# UNITED STATES PATENT AND TRADEMARK OFFICE

APPLICATION NO.	FILING DATE	FIRST NAMED INVENTOR	ATTORNEY DOCKET NO.	CONFIRMATION NO.
10/663,051	09/15/2003	Gordon Ma	068736.0232	1994

## Office Action Summary

**DETAILED ACTION*****Drawings***

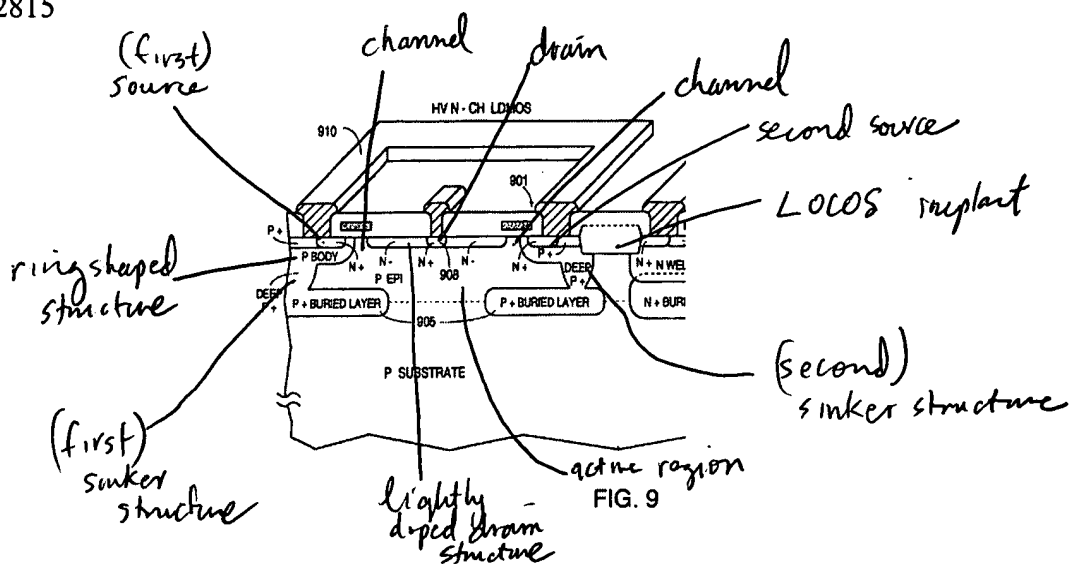
4. Claims 1 thru 4, 6, 11 thru 13, 16, 18 thru 21, 23, 25 thru 27, 30, 32 thru 35, 37, 39, 41, and 42 are rejected under 35 U.S.C. 102(b) as being anticipated by Williams et al. 5,386,136. Williams discloses (see, for example, FIG. 9) a semiconductor device comprising a p epitaxial region (active region of a first conducting type), transistor, and P-body (ring shaped region of the first conductive type). In column 8, lines 29-32, Williams discloses the P-body as being an annular structure (ring shaped).

Regarding claims 2, 19, and 33, see N+ region (drain) 908, N+ region (source), channel, gate, and deep P+ region (sinker structure).

Regarding claims 4, 21, and 35, see N- region (lightly doped drain region) next to the N+ region 908.

Regarding claims 6, 20, and 34, see FIG. 9 above wherein two transistors share a N+ region (common drain) 908, have a first source region and a second source region each defining a channel and first and second deep P+ regions (first and second sinker structure).

Regarding claims 11, 25, and 39, see FIG. 9 above wherein a LOCOS implant encloses semiconductor device.

Regarding claims 12 and 26, see FIG. 9 above wherein a P substrate and P epitaxial layer.
